**CLARK COUNTY
STAFF REPORT**

DEPARTMENT: Community Development, Development Services
DATE: July 25, 2013
REQUEST: Approve a Declaration to amend Burnt Bridge Village Subdivision Plat Recorded in Book 311 at Page 638.

DECLARATION AMENDING PLAT BOOK 311, PAGE 638

Project Name: BURNT BRIDGE VILLAGE

SUBJECT: Sight Distance Analysis Side Yard Variance to Lot 43, Burnt Bridge Village. REVISED

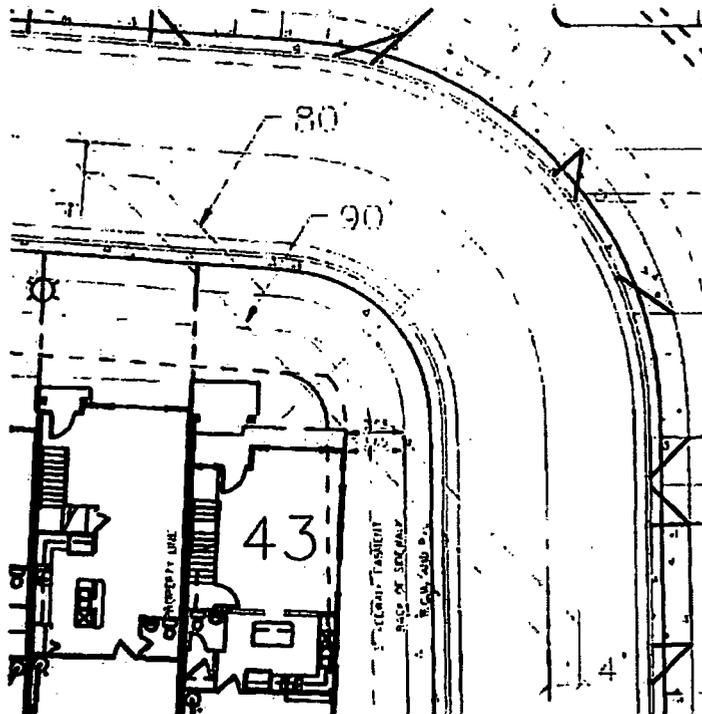
1. Variance request consists of a street side yard setback reduction from 10-feet to 7.53 feet (24.7%).
2. The worst case for available sight distance would be along the line perpendicular to a radial line from the mid-point on the travel lane curve and through the point of obstruction.
3. The centerline radius of the near lane is 29.5 feet. Design speed is defined as $R=V^2/15(e+f)$. For this radius it would round up to 10mph.
4. Stopping sight distance for 10mph is $d=V^2/30f$. For this curve stopping site distance rounds up to 20 feet. With a reaction time of 2.5 sections the total stopping distance is 57 feet.

5. Stopping sight distance for 10mph is $d=V^2/30f$. For this curve stopping site distance rounds up to 20 feet. With a reaction time of 2.5 sections the total stopping distance is 57 feet.

-
6. Available site distance at the proposed building location (with the requested variance) is over 90 feet.
 7. The County has stated that required site distance is 80-feet. 80-foot site distance is available outside of the building setback as shown on the figure.
